ACCESSION NBR: 8206210276 DOC. DATE: 82/06/16 NOTARIZED: NO DOCKET #
 FACIL: 50-387 Susquehanna Steam Electric Station, Unit 1, Pennsylv 05000387
 50-388 Susquehanna Steam Electric Station, Unit 2, Pennsylv 05000388
 AUTH. NAME AUTHOR AFFILIATION
 CURTIS, N.W. Pennsylvania Power & Light Co.
 RECIPIENT NAME RECIPIENT AFFILIATION
 SCHWENCER, A. Licensing Branch 2

SUBJECT: Expounds on agreements reached at 820524 meeting W/NRC re voltage study. Four design changes identified for support of Unit 1 operation. Mar test fulfills requirement for voltage verification test. Supporting documentation encl.

SUSQUEHANNA STEAM ELECTRIC STATION
NRC MEETING MAY 24, 1982 ACTION ITEM RESPONSE
ER 100450 FILE 841-3
PLA - 1137

SIMPLIFIED CONTROL DIAGRAM TO ILLUSTRATE LOCA INITIATION OF STARTUP TRANSFORMER LOAD TAP CHARGER (LTC)

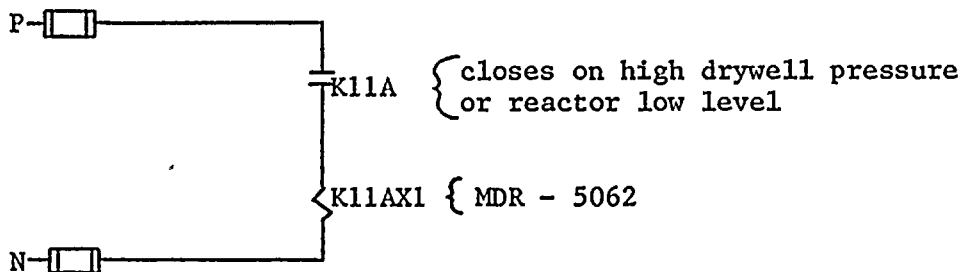
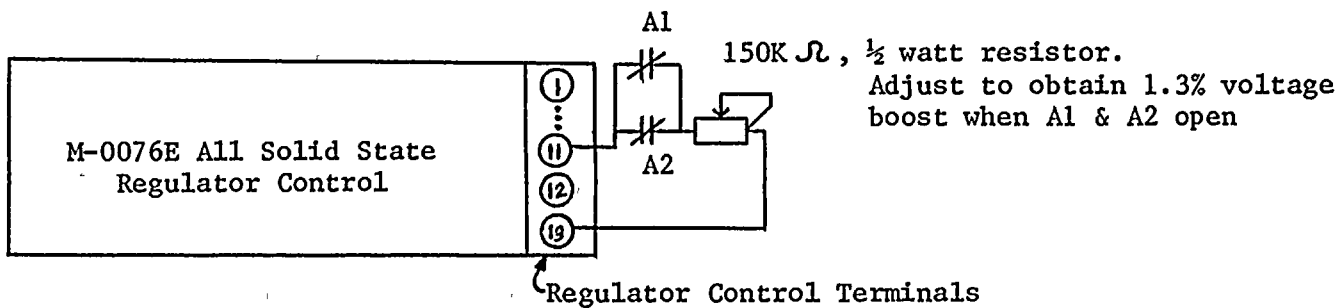
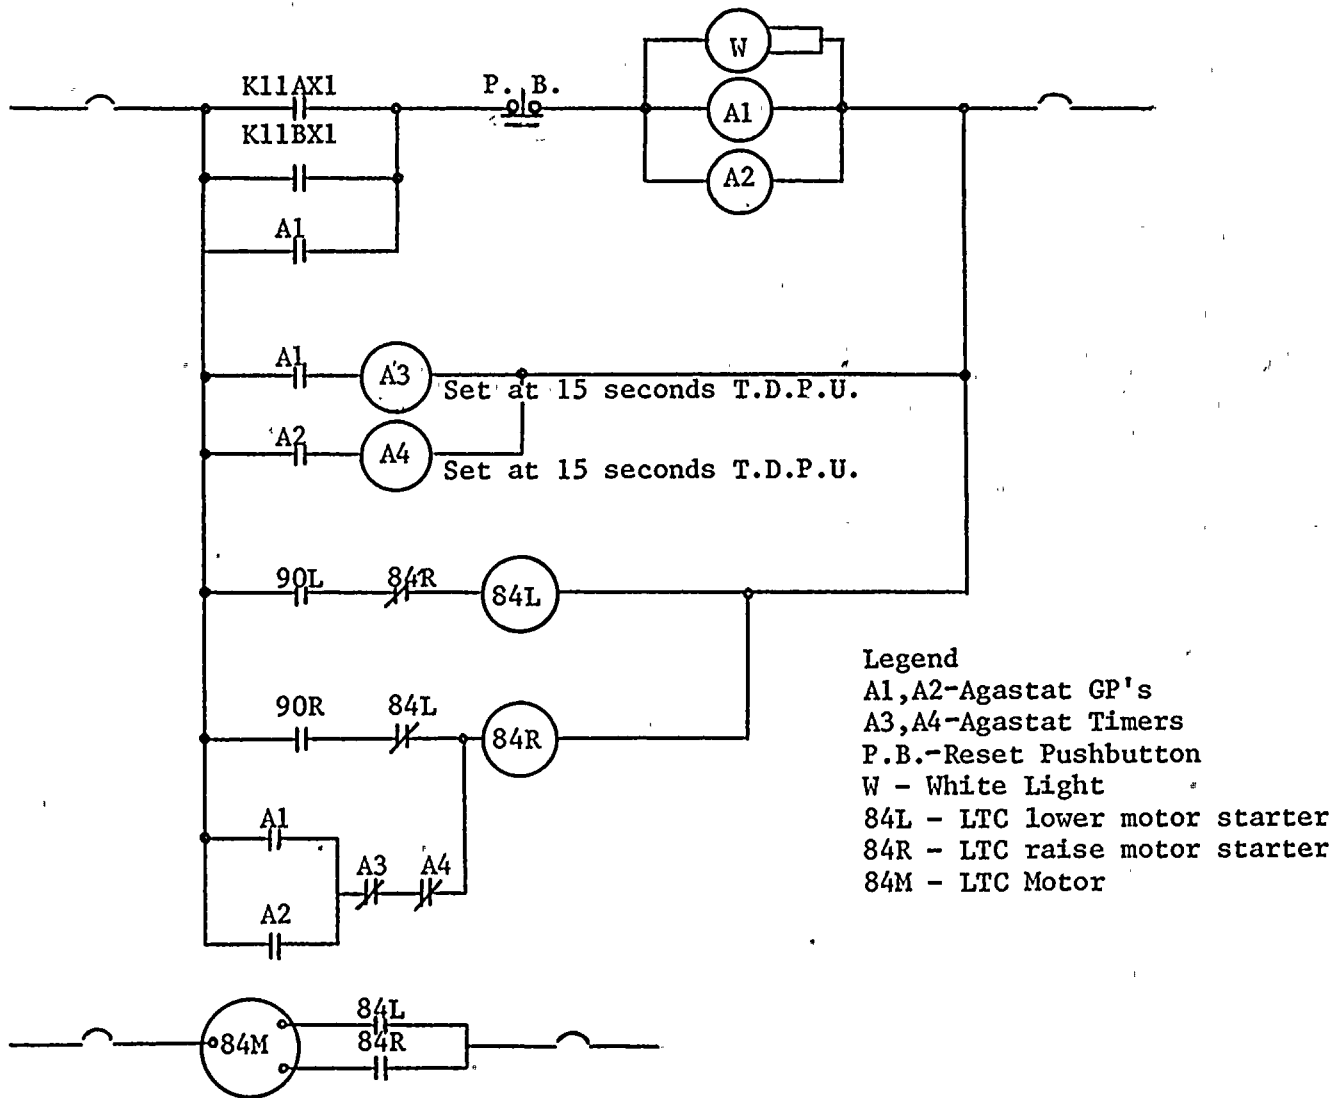
The attached Figures 1, 2, and 3 show the circuitry in simplified form that automatically changes the regulated voltage level by +1.3% at the 13.8KV side of the automatic tap changing Startup Transformer. The circuitry changes the reference level in the tap changer control (Figure 2) for a LOCA so the Startup Transformer automatically maintains the 13.8KV voltage within a bandwidth 1.3% higher than normal. The circuitry also bypasses the normal tap changer time delay (Figure 3) for 15 seconds so an immediate increase in voltage occurs for a LOCA if the tap changer is out of its regulating bandwidth.

- Design intent:
- 1) Increase startup bus voltage schedule 1.3% for a LOCA.
 - 2) Initiate startup transformer LTC's for a LOCA. Provide for automatic release of this initiation 15 seconds after a LOCA.

Figure 3: Reference PP&L Foreign File FF-61583, sh. 5, Rev. 1. For a DBA, A1 & A2 operate, A1 seals in, A2 alarms. When A1 and A2 operate the LTC controller is biased (Figure 2). Twenty seconds later (inherent delay in controller) controller maintains revised voltage schedule. When A1 or A2 operate, 84R is immediately energized and LTC raise is initiated. A1 and A2 energize A3 and A4 which defeat A1 or A2 LTC raise after timing out.

SIMPLIFIED CONTROL DIAGRAM TO ILLUSTRATE CIRCUITRY THAT TRIPS UNIT II 4.16KV LOADS FOR UNIT I LOCA.

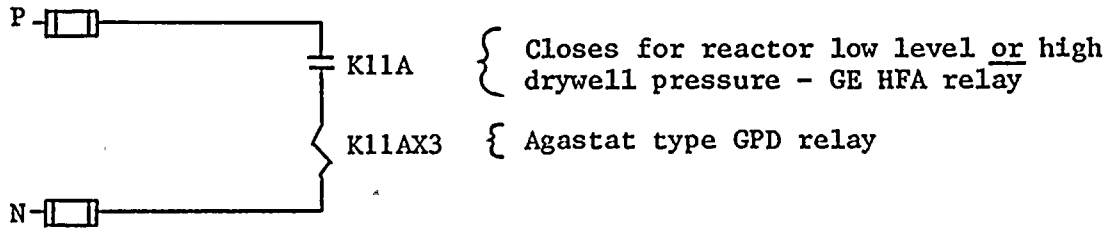
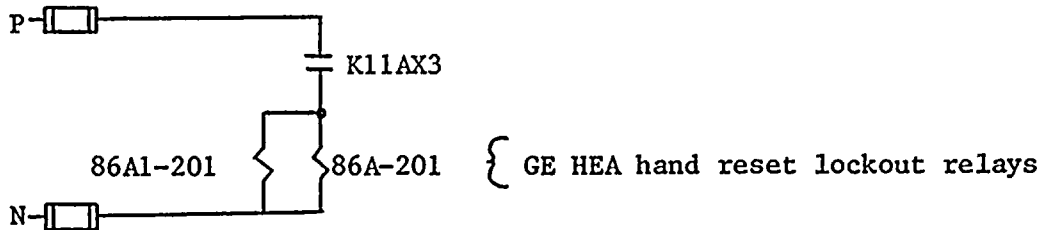
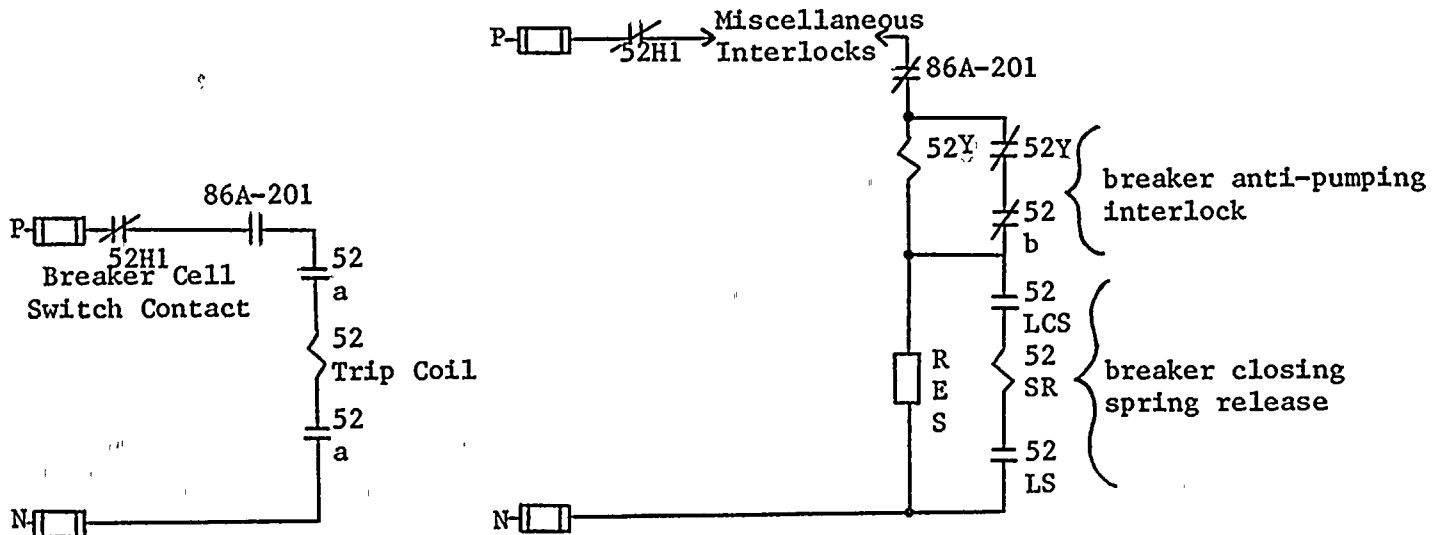
The attached Figures 4, 5 and 6 show the simplified automatic trip scheme of the Unit 2 Class 1E switchgear for a LOCA in Unit 1. The circuitry actuates each Unit 2 4KV bus lockout relay (Figure 5) which trips and locks out all power supply breakers to their respective buses (Figure 6).

Design Intent: For a Unit I LOCA, the Unit II 4.16KV bus lockout relays will operate, trip and block closing of all Unit II 4.16KV breakers.

Figure 5: Reference E-103 sh. 14 (typical)
Unit II 4.16KV bus lockout relays which operate for Unit I LOCA
